Agenda Item: Water View Phase 2 School Project Infrastructure Improvements

Agenda Item: Civic Center HVAC Change Order No. 1

Re: **Change Order No. 1**
Willmar Civic Center HVAC Improvements
Stevens File No. 900-14-231

CONSTRUCTION DOCUMENTS
Sheet No. **HVAC DEMOLITION PLAN**

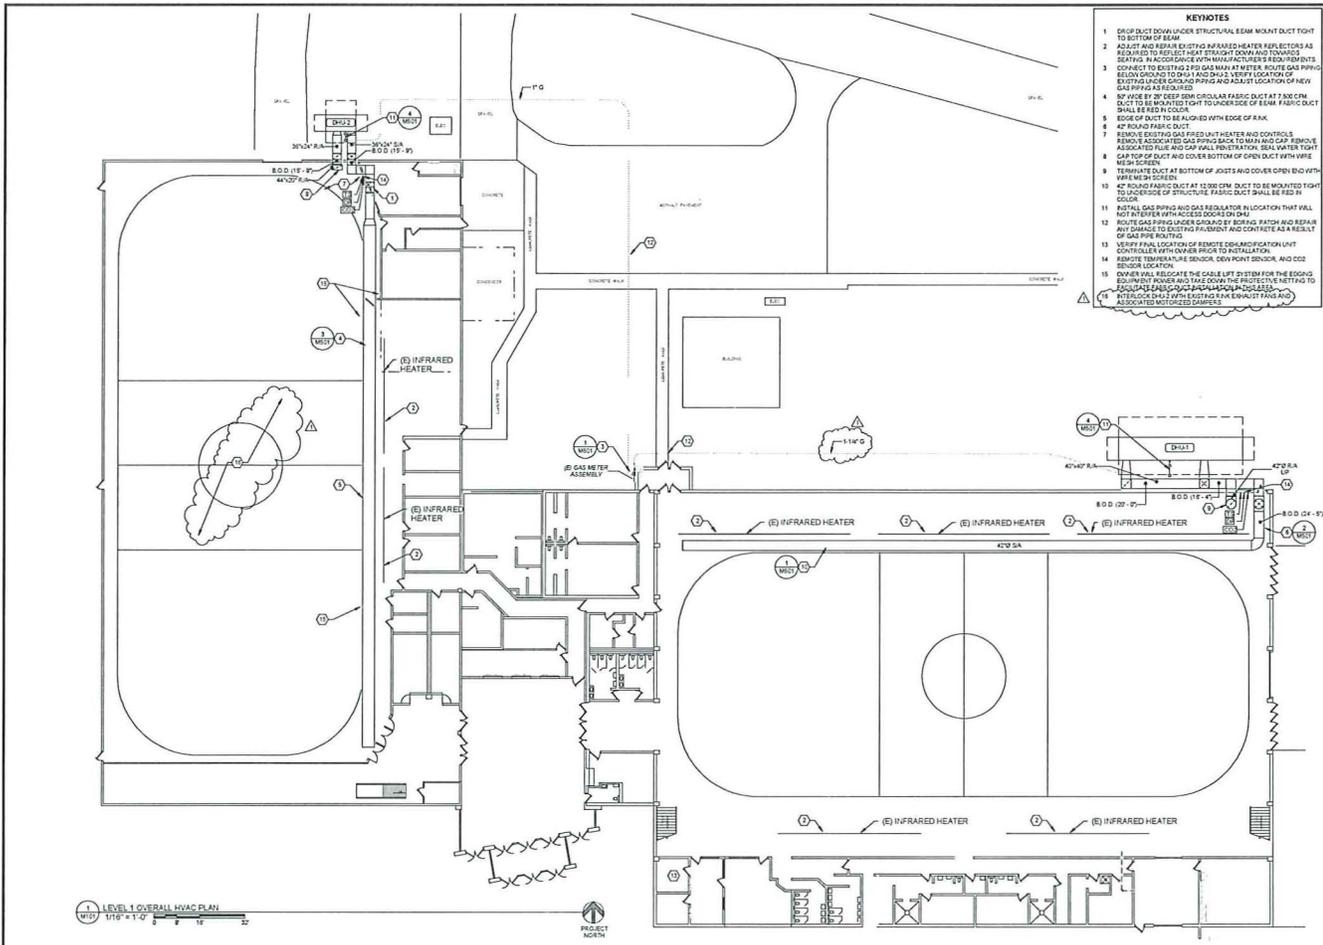
Demolition Plan | 1. Revised keynote 8. |
